ENGINEERING ORDER

1. ENGINEERING ORDER NO. 2010C1046-T

2. DWG TITLE	3. DWG CAGE CODE	4. DWG NO.
PROPORTIONER SUB ASSY	86090	44143

This EO adds Item Unique Identification (IUID) requirements to the drawing

5. DESCRIPTION OF CHANGES/REMARKS

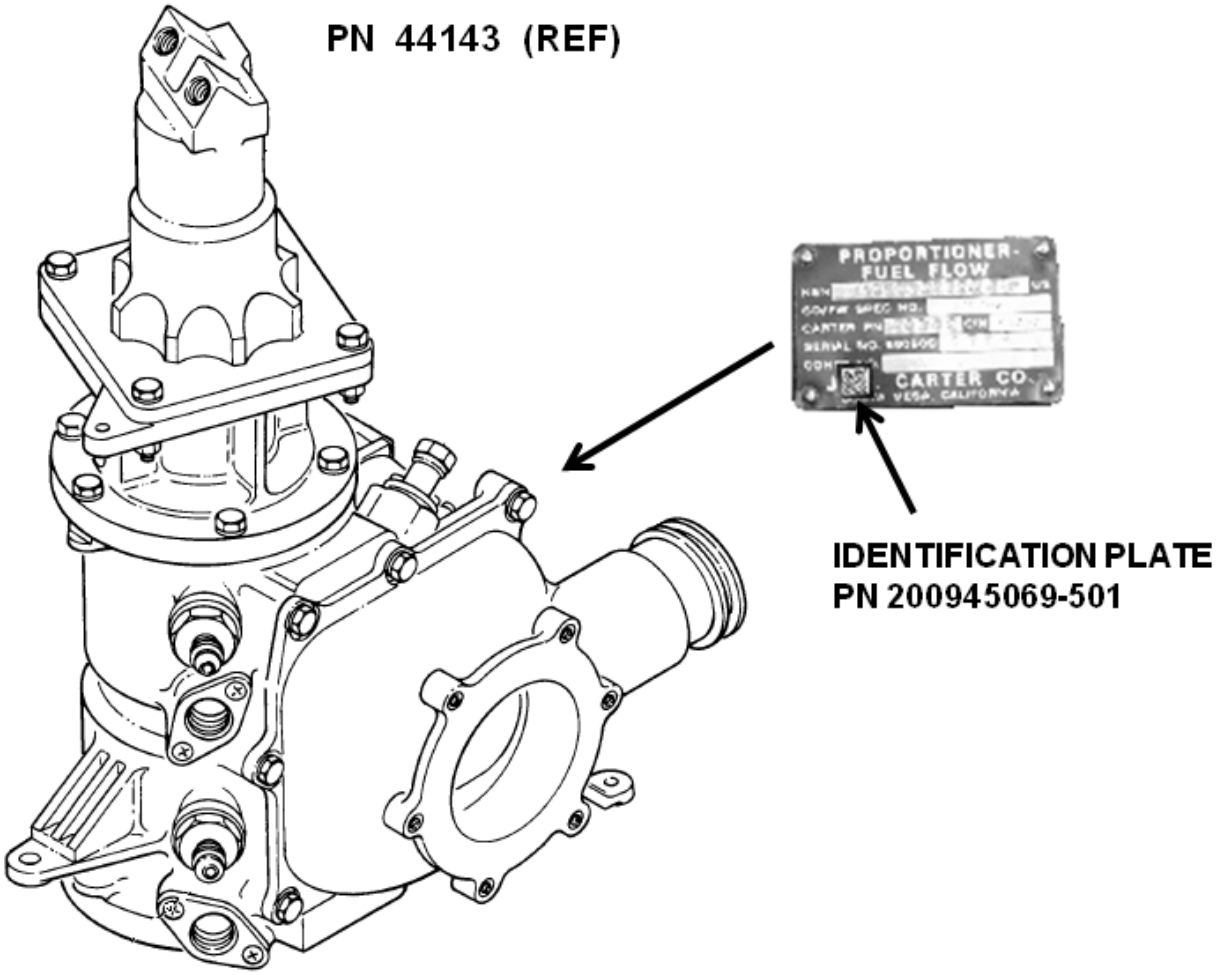
- The new UID identification plate will be located on the existing plate/label as shown in sketch/photo on page 2, AF form 3926.

- If no UII matrix is present, fabricate new identification plate (200945069-501) and attach to the existing identification plate/label (204619).

- After attaching IUID plate to the existing identification plate/label , apply a thin overcoat to IUID plate ensuring the plate edges are sealed, using 1A20, 1A33 or equivalent Polyurethane Conformal Coating, per manufacturer''s instructions. REF: MIL-I-46058C
